SERVICETEKNOTES

TABLE OF CONTENTS

Figure 1

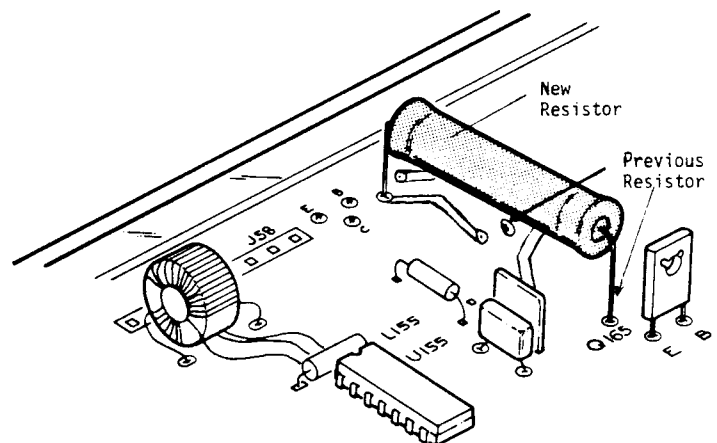
The display board in the 4006-1, 4051/52/52A products is experiencing a high failure rate due to high AC line voltages causing the failure of R64, R339, and Q165. The failure of R64 can generate enough heat to scorch, or even burn, the board.

Corporate modification #54922 fixes this failure mode by changing the value, wattage and placement of R64, and changing the source voltage of the CE1/CE2 circuit from +320 volts to +185 volts. To accomplish this, R64 is physically repositioned. It now connects between the +185-volt source (R39) and the collector of Q165. Physically, it will be positioned as shown in Figure 1.

R64 changes from 68K 2W resistor, P/N 305-0683-00, to a 30K 8W resistor, P/N 308-0105-00. The Display board for the 4006-1 changes from a 672-0537-11 to a 672-0537-12 and the Display board for the 4051/52/52A changes from a 672-0546-11 to a 672-0546-12.
